**CITY OF KIRKLAND**

**ADVISORY REPORT  
FINDINGS, CONCLUSIONS, AND RECOMMENDATIONS**

**File:** HIGHLAND GLEN SHORT PLAT, WETLAND AND WETLAND/STREAM BUFFER MODIFICATIONS,  
AND VARIANCE, FILE NO. SPL07-00034

- Figure 8 (Proposed Site Plan & Conceptual Mitigation Plan) – 4 copies
- Figure 9 (Conceptual Planting Plan & Schedule) – 4 copies
- Sheet W1.2 (Mitigation Plan) – 4 folded copies
- Sheet W2.0 (Conceptual Planting Plan & Schedule) – 4 folded copies

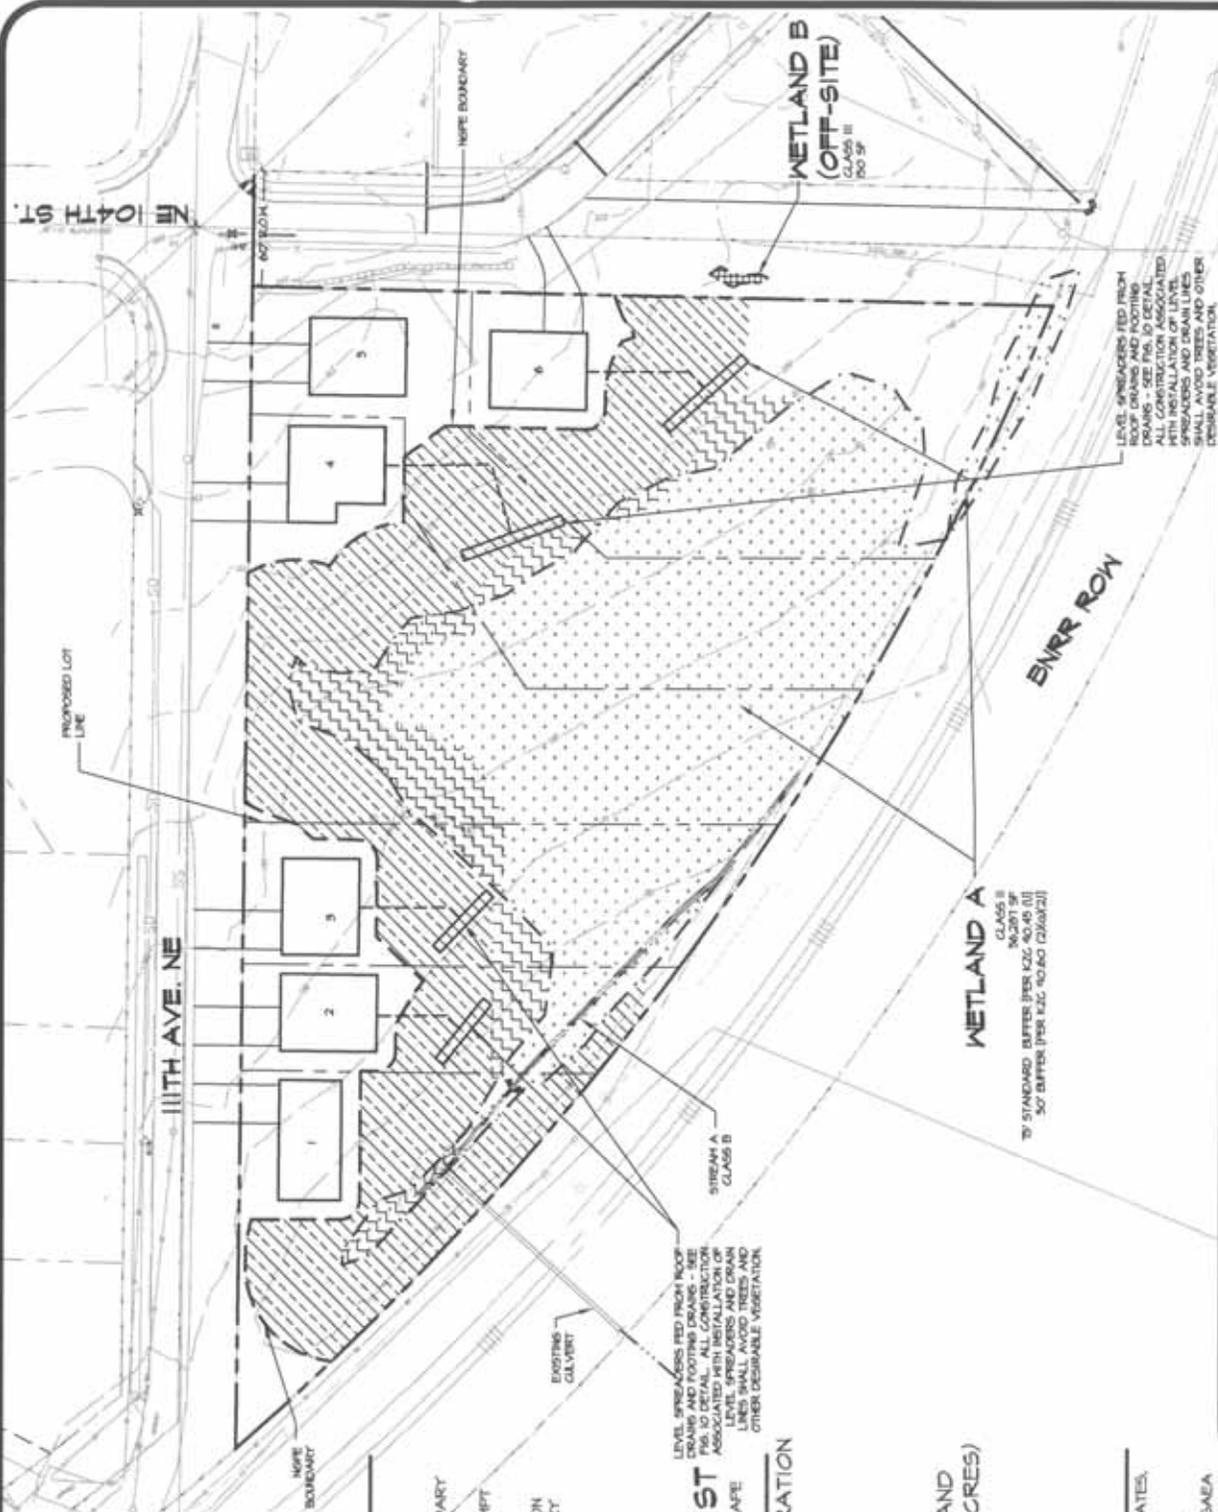
- Comment #3 – *The following plants should be removed from the Conceptual Planting Plan: Shore pine, high bush cranberry, and evergreen huckleberry.*
- Response #3 – These plants have been removed from sheet W2.0 in the Critical Areas and Conceptual Mitigation Plan (see attachment).
- Comment #4 – *The larger ball & burlap tree sizes do not perform as well as the smaller container stock*
- Response #4 – The larger ball & burlap tree sizes have been removed from sheet W2.0 in the Critical Areas and Conceptual Mitigation Plan (see attachment).

- Response #1 - Based on field observations, we have relocated the wetland creation area to a more appropriate location. The 50' buffers for the new wetland creation areas do not extend beyond the property line and are in areas that do not exceed a 4.5:1 slope. See Figures 8 & 9 (attached with this letter) for more detail.
